1U solution for Intel LGA1150 LGA1155 LGA1156 Xeon 1230 CPU Socket clip
April 12, 2019

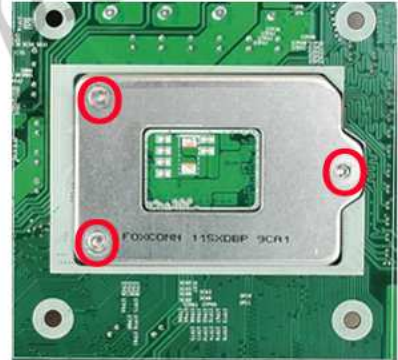
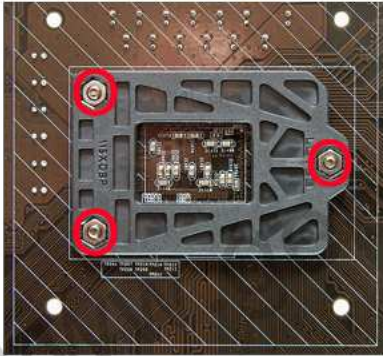
- Solution 1: Shorten the 3 screws at back side of motherboard, see above RED circles
Solution 2: or Drill 3 holes at bottom of 1U chassis in order to accommodate the longer screws
Solution 3: If neither the 1st nor the 2nd solution, please order some #6 x 6mm high screws and some 5mm high plastic stand-off, see the photo below.
